Caledon Pit & Quarry

18722 Main Street, Caledon, Ontario

Operational Plan

The redline revisions shown on this drawing represent all of the changes that have been made since the August 2023 Aggregate Resource Act site plan.

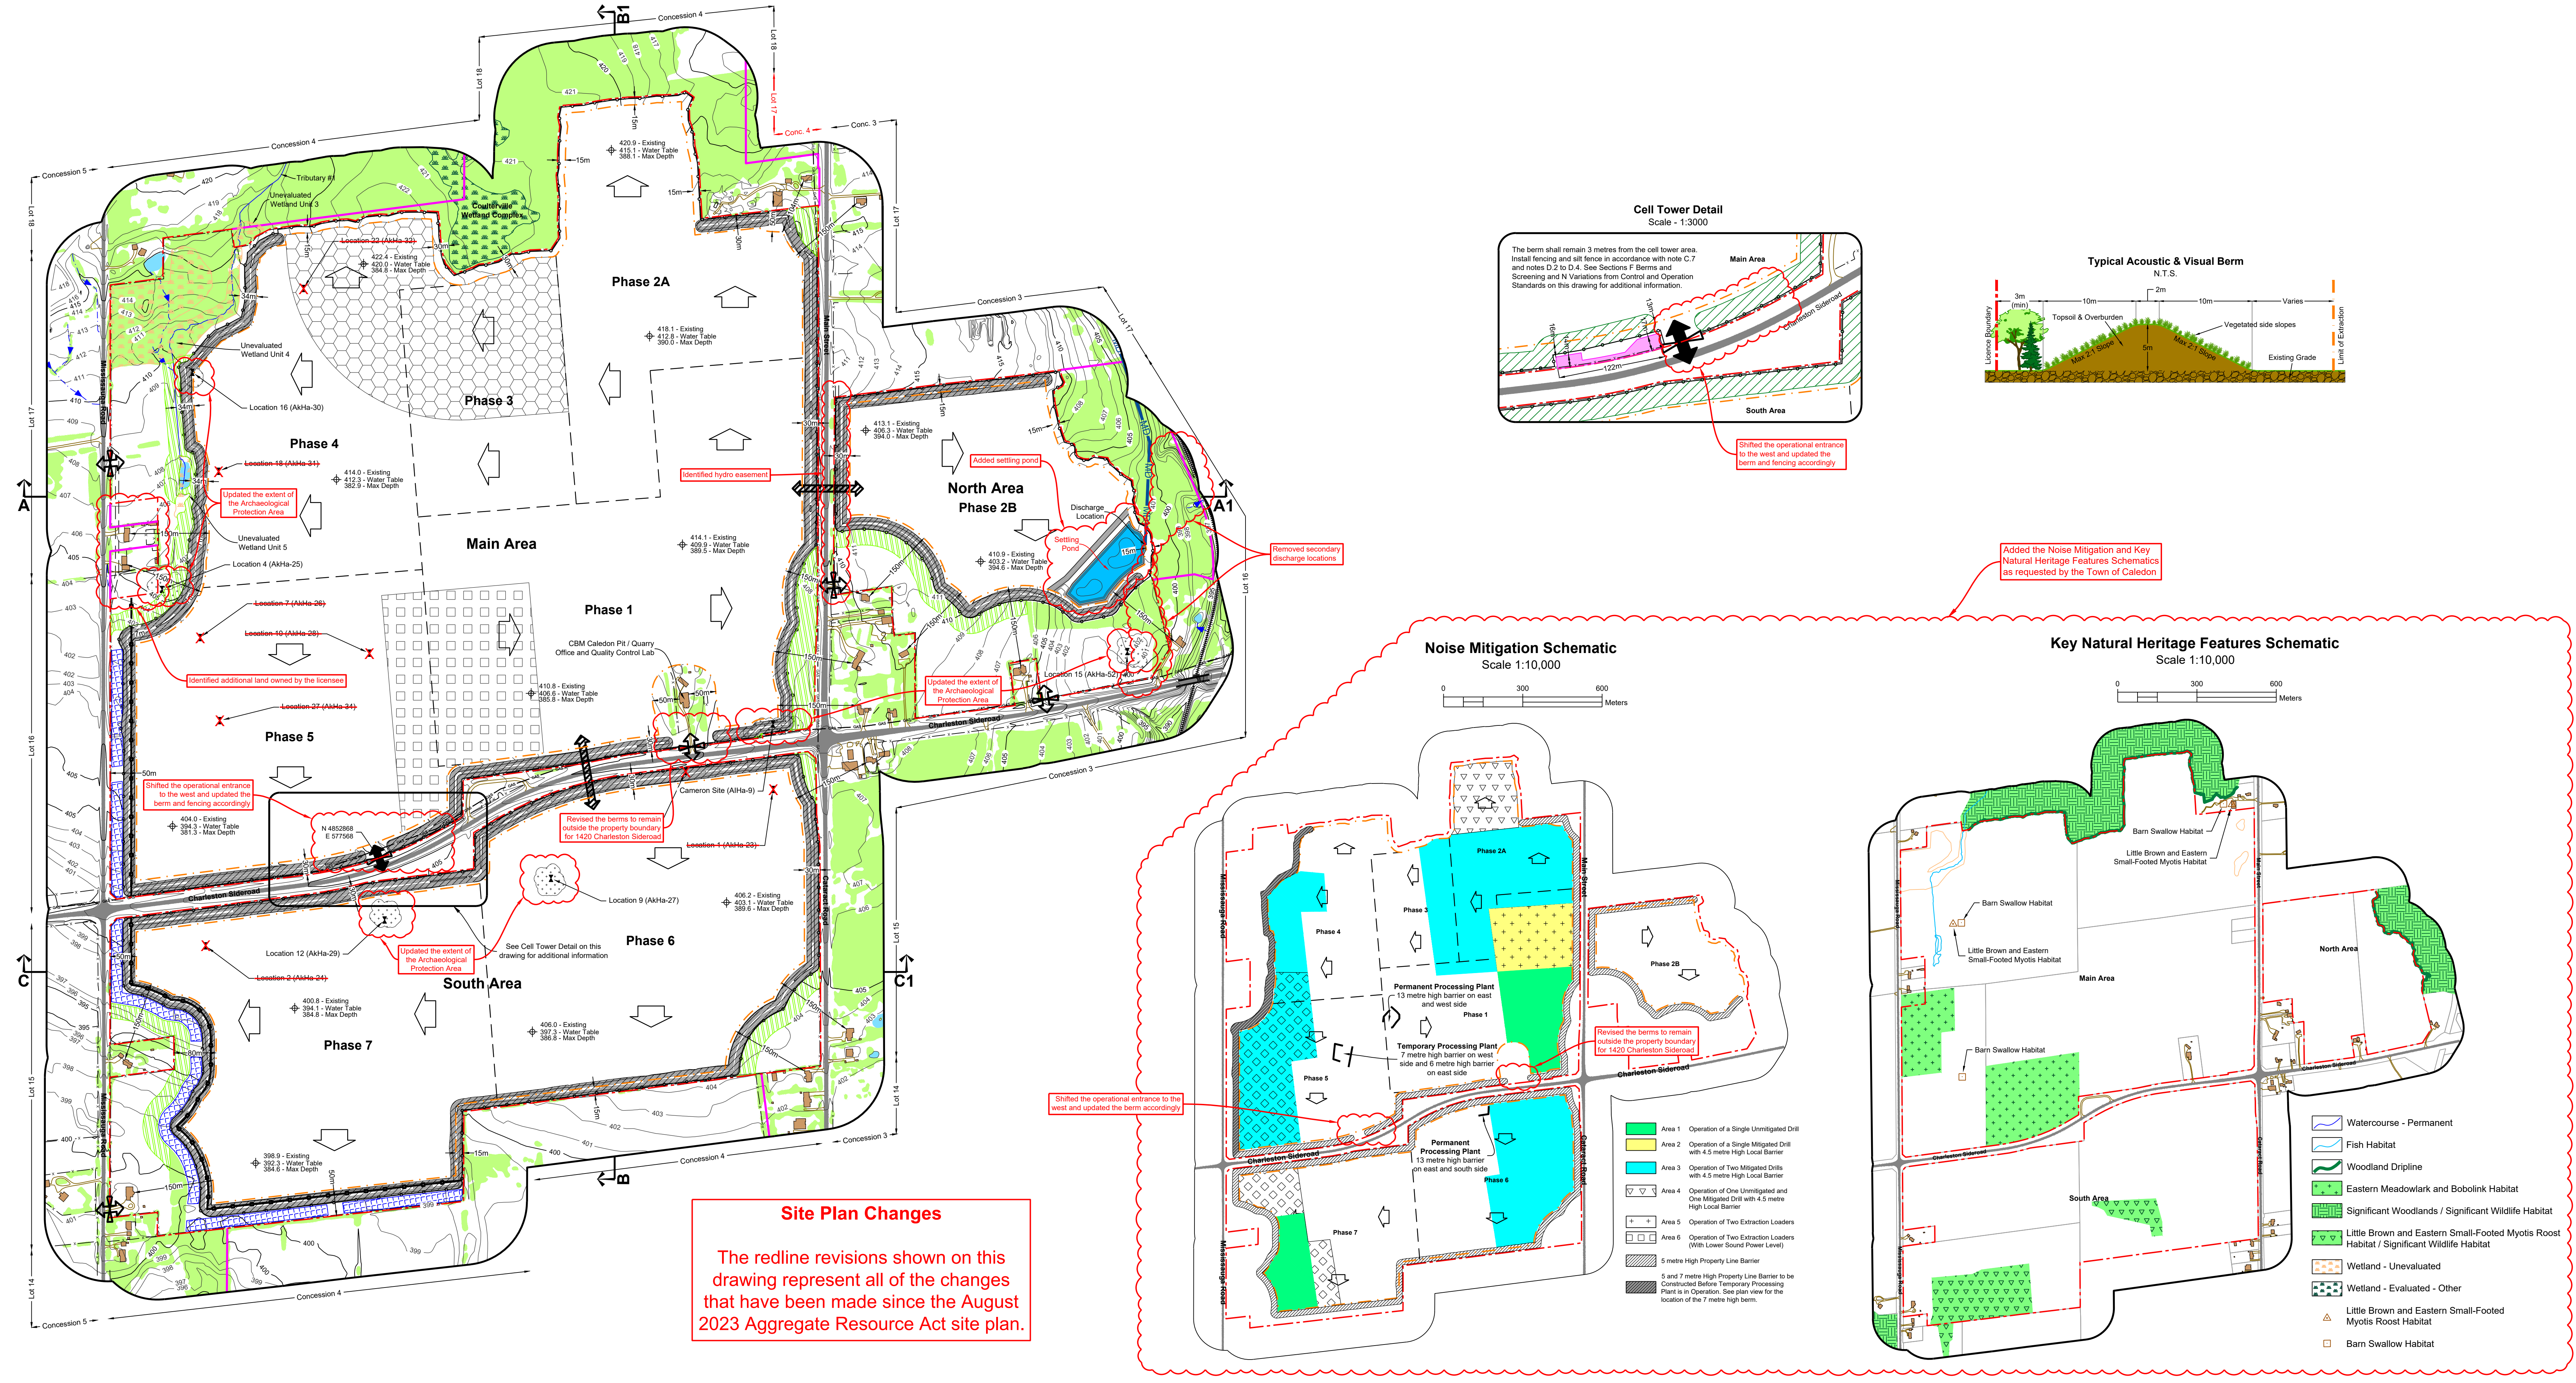
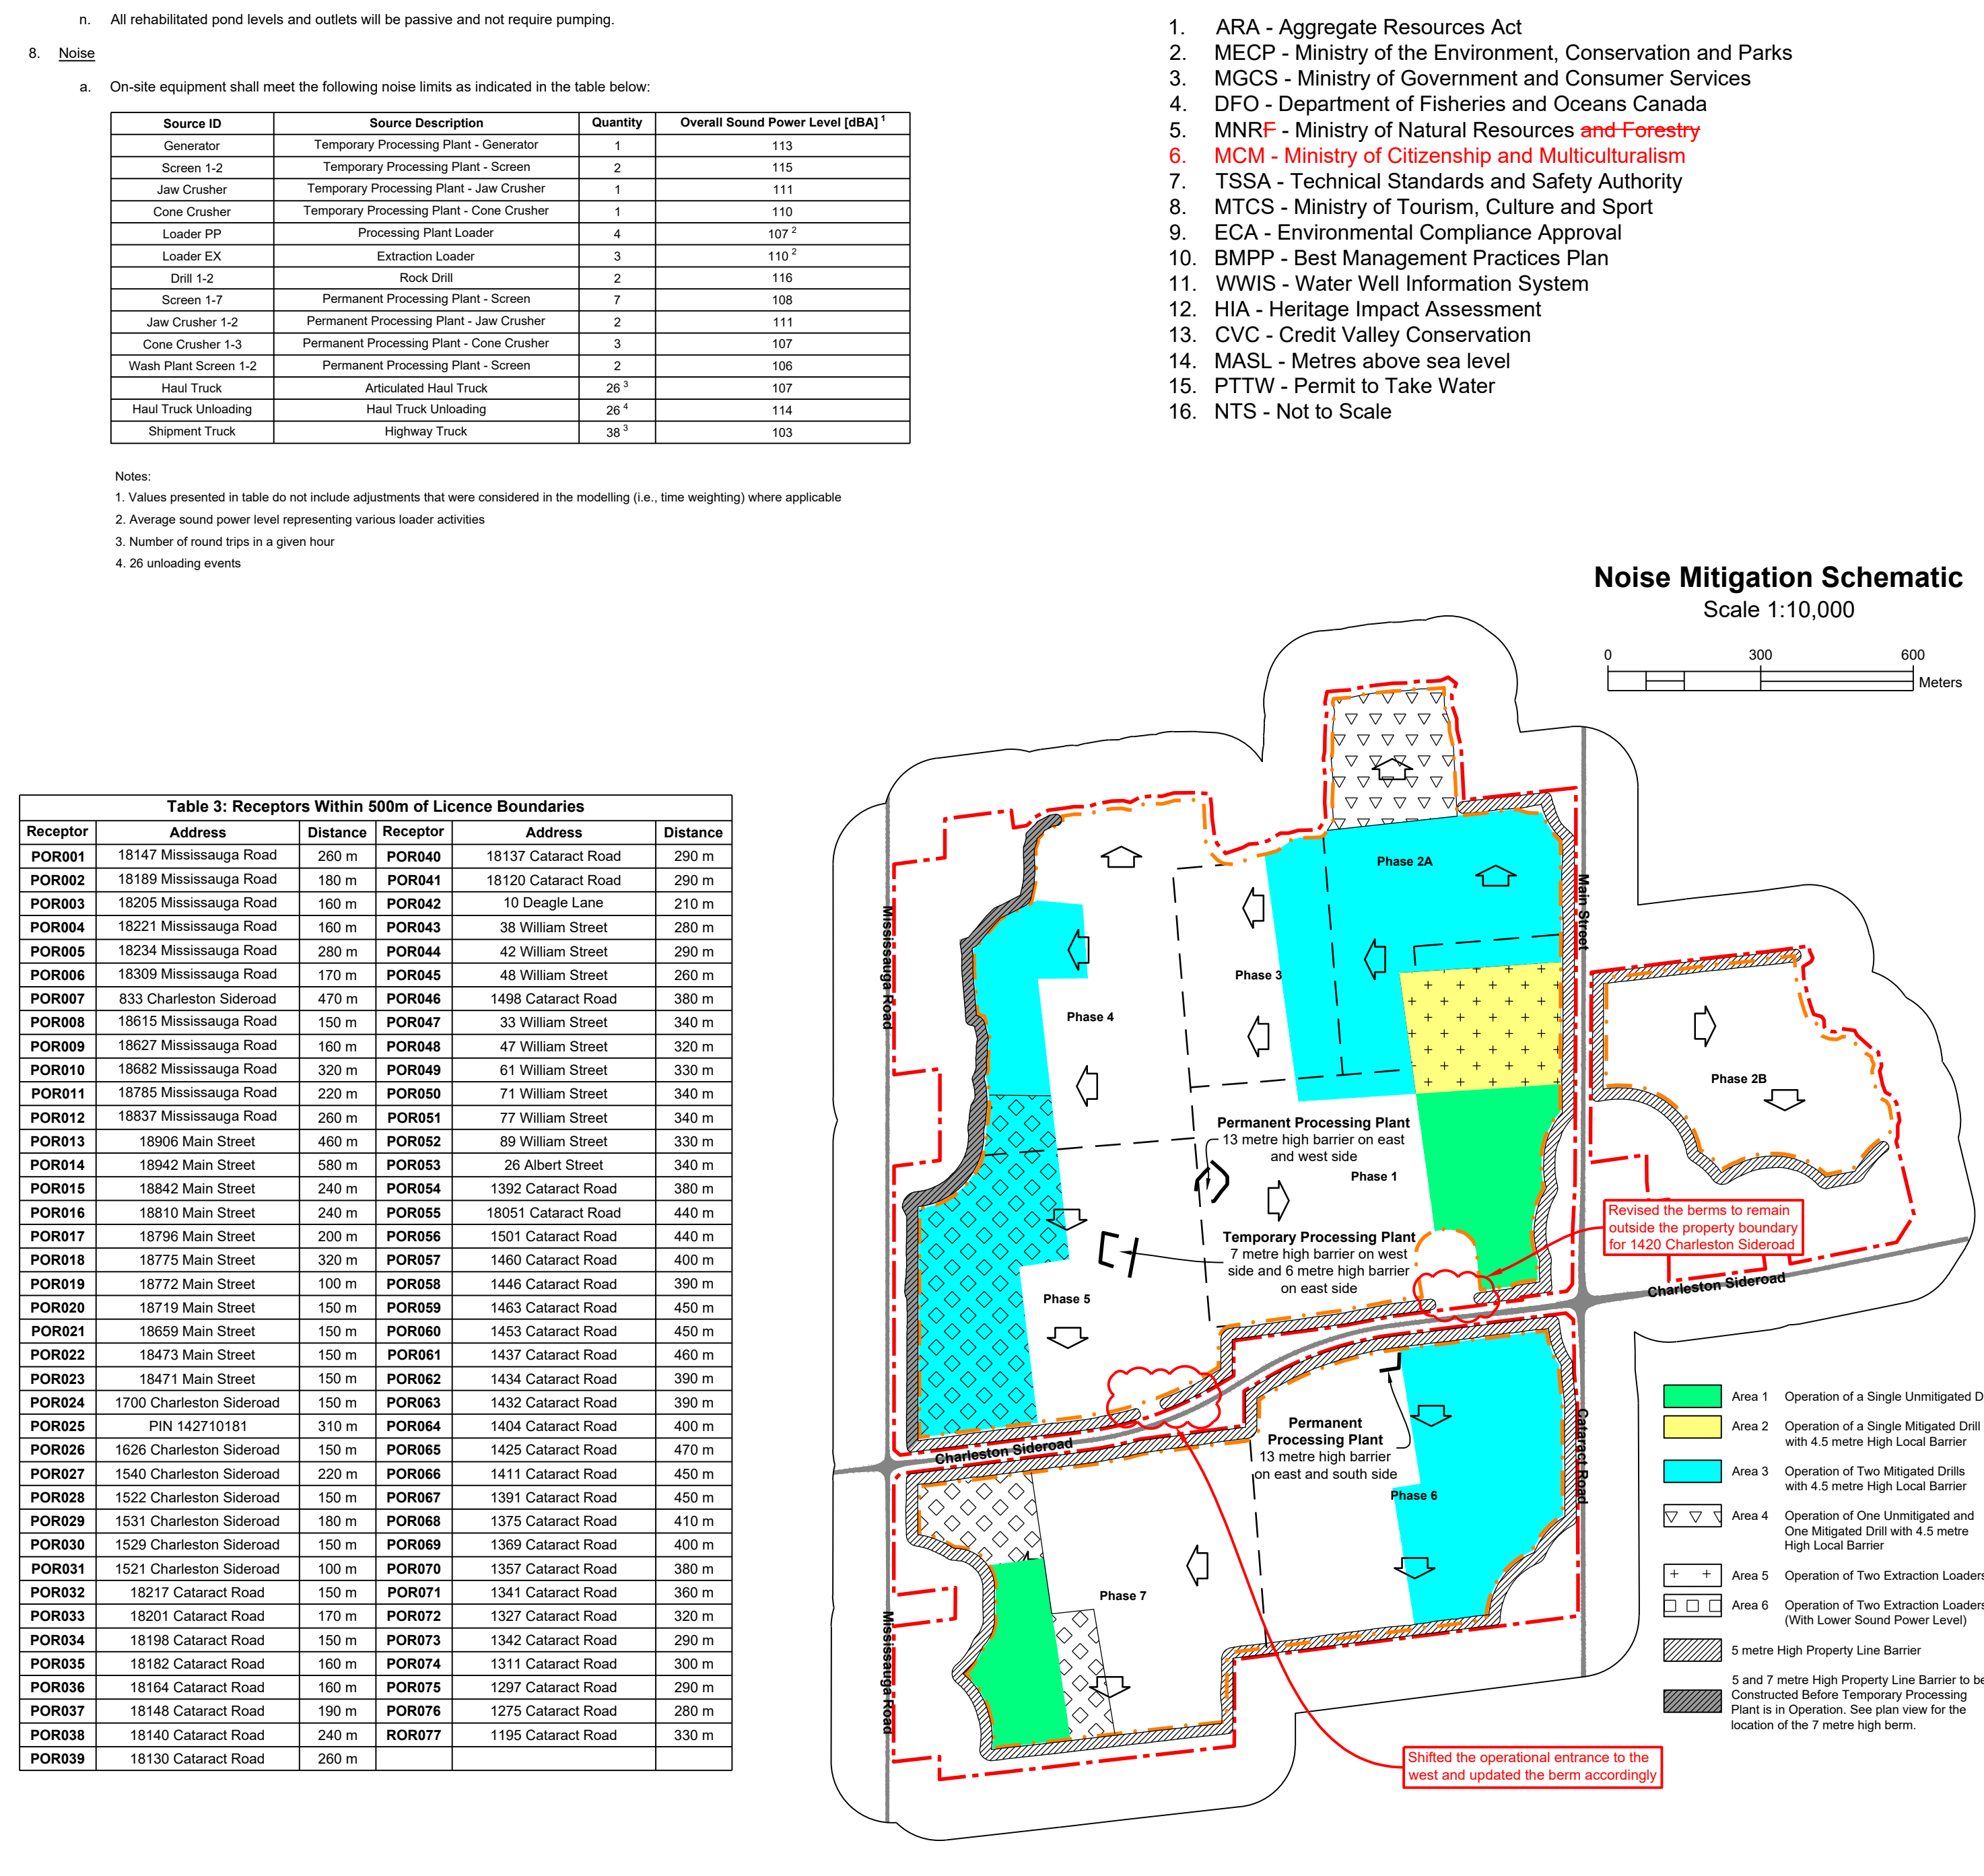
A	a. Quality	b.	c.	d.
1.	<p>The site shall operate in accordance with the Fugitive Dust Best Management Practices Plan (BMPP) dated December 2002, <i>last revised April 2011</i> (2011). The BMPP that be reviewed annually and updated if required based on current Site operations and new best management practices.</p>

Rehabilitation Plan

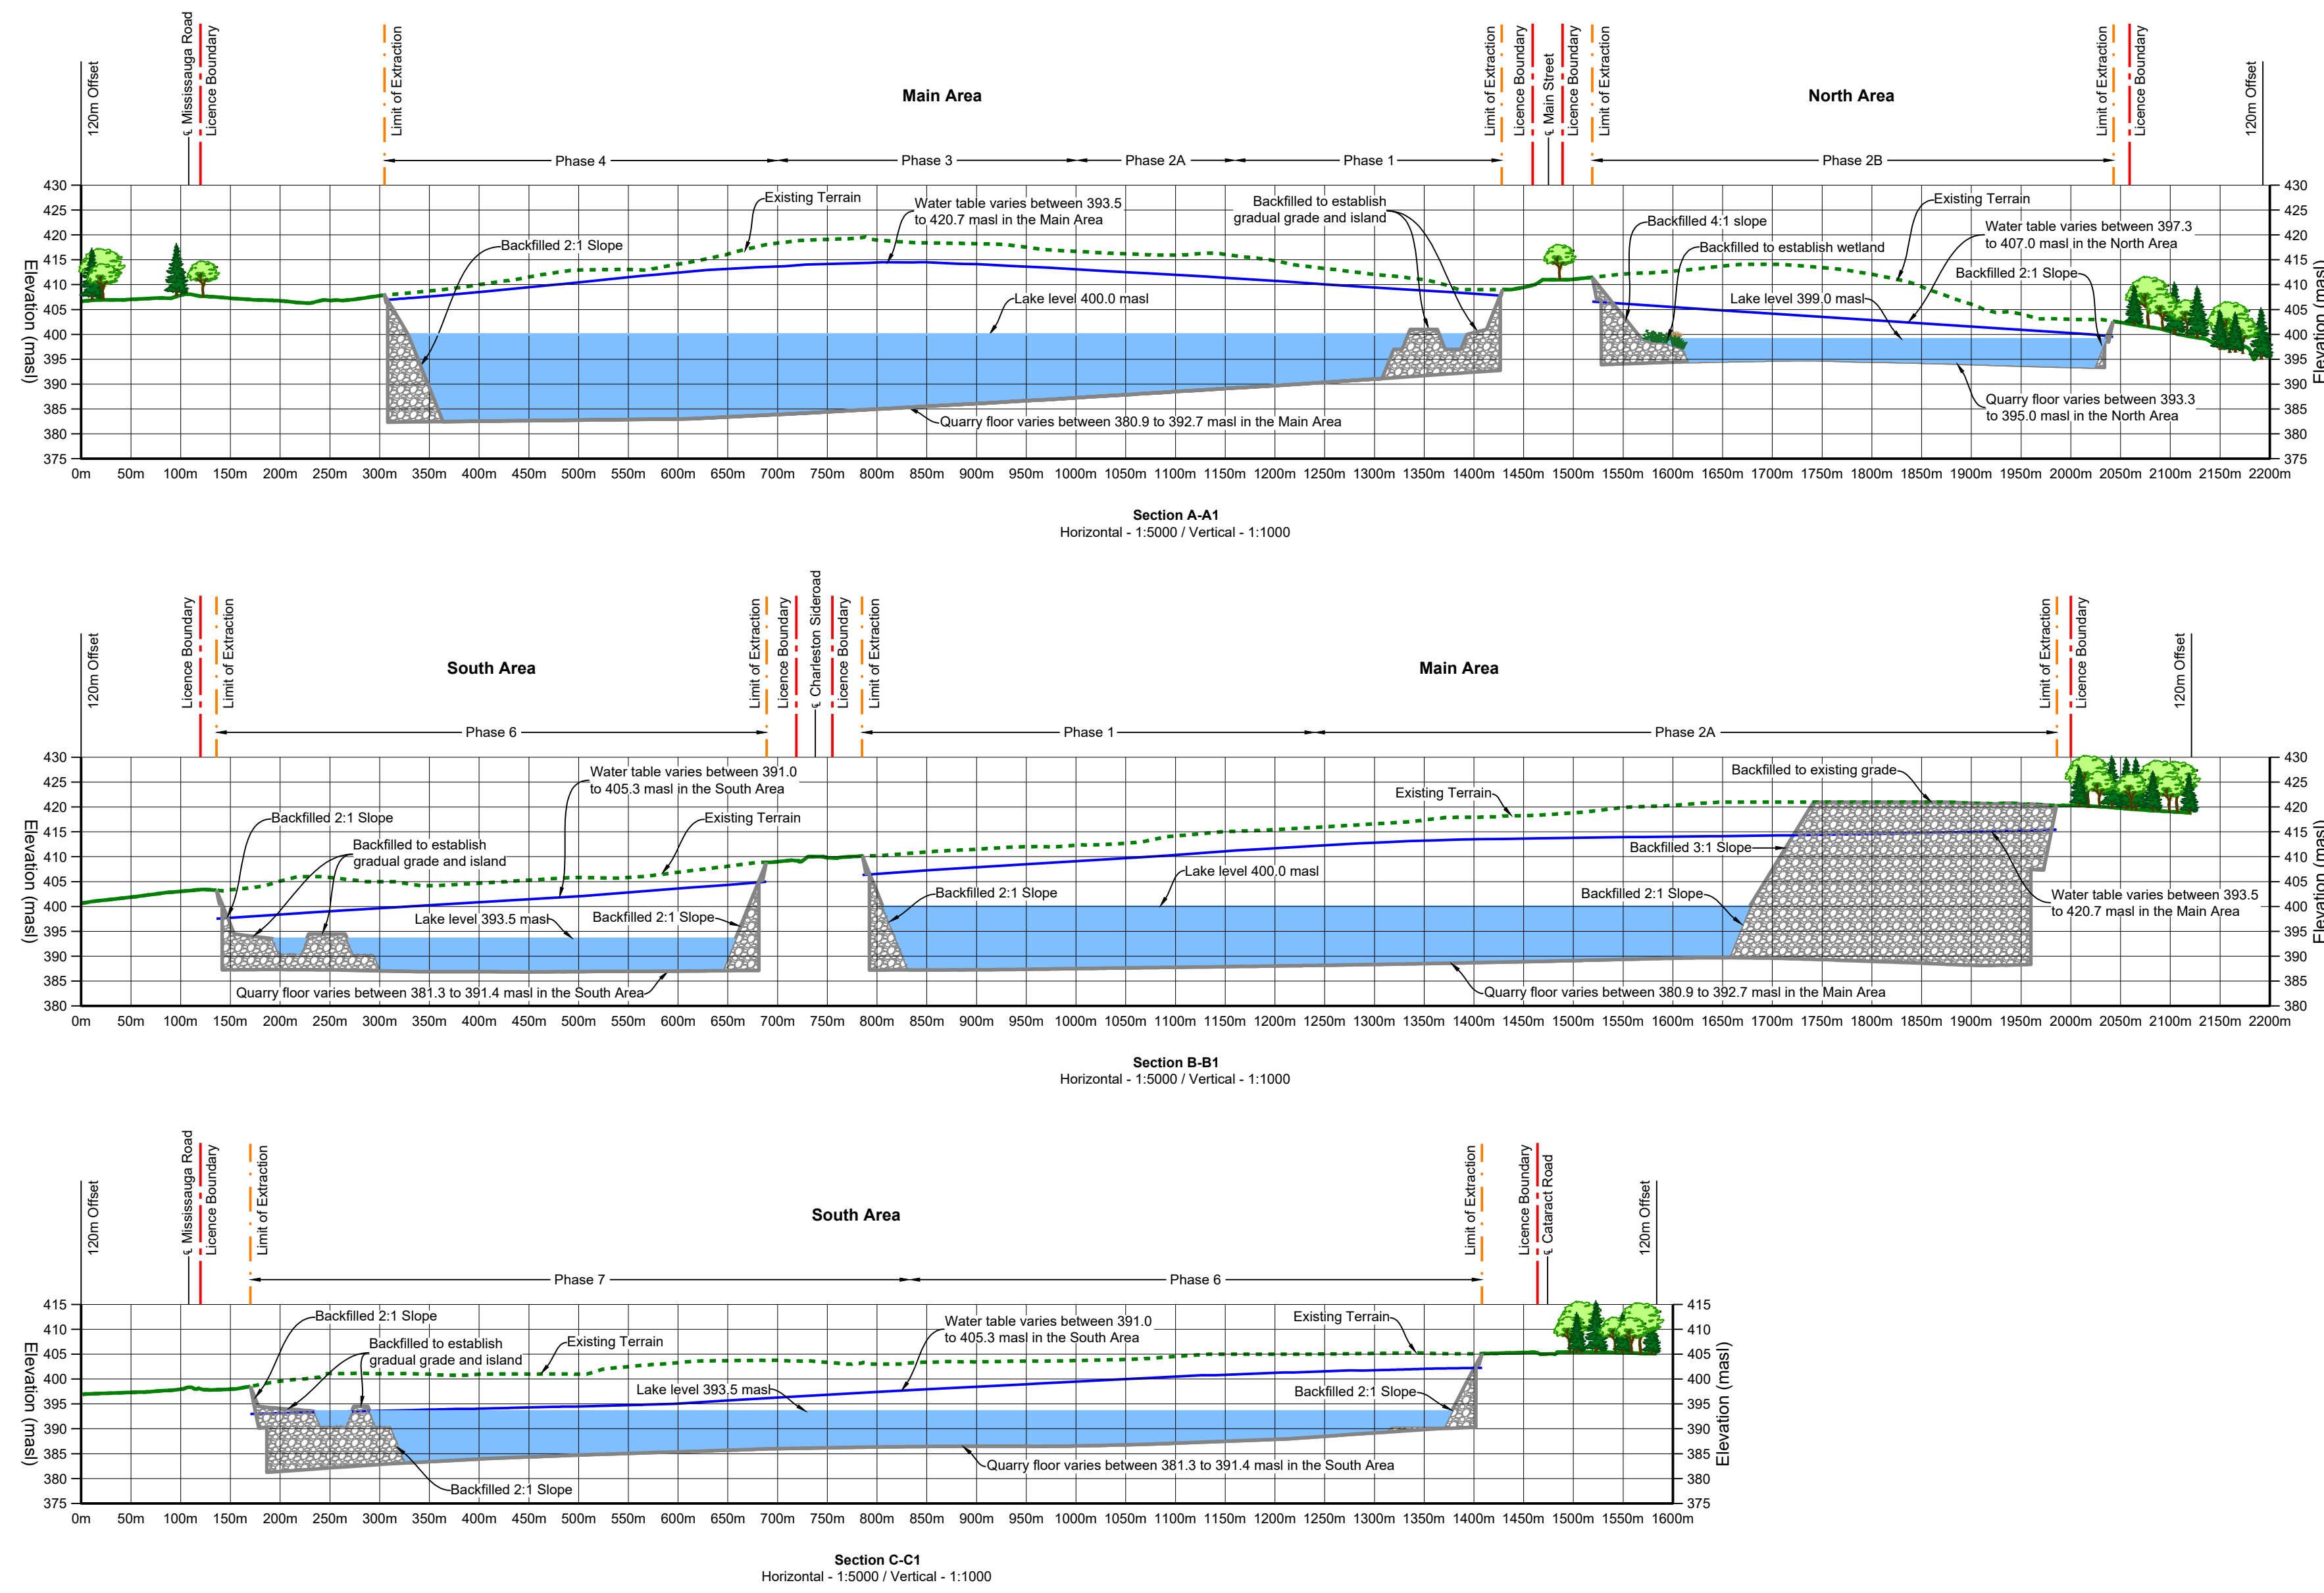
The redline revisions shown on this drawing represent all of the changes that have been made since the August 2023 Aggregate Resource Act site plan.
